UPDATE CHANGE NOTIFICATION # 16746

Issue Date: 22-Mar-2012

TITLE: Deleted the Sleeve (Tube) device name from the PB16746 which change packing standard by removing protective band from plastic reel at ON Semiconductor (Thailand).

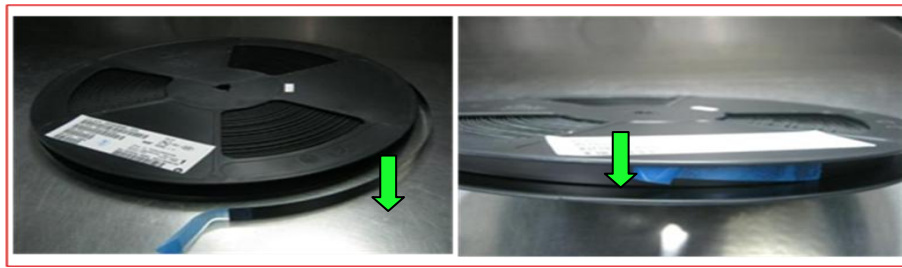
Before Change: The protective band covers the reel then closes the end by Blue ESD tape.

After Change: Blue ESD tape closes the end of the reel packing.

Before Change: Carrier tape + protective band + ESD tape (short length around 5 cm.)

After Change: Carrier tape + ESD tape (increase length to 20 cm for small package and 30 cm for SOIC and TSSOP, this will prevent the reel to easily peel off)
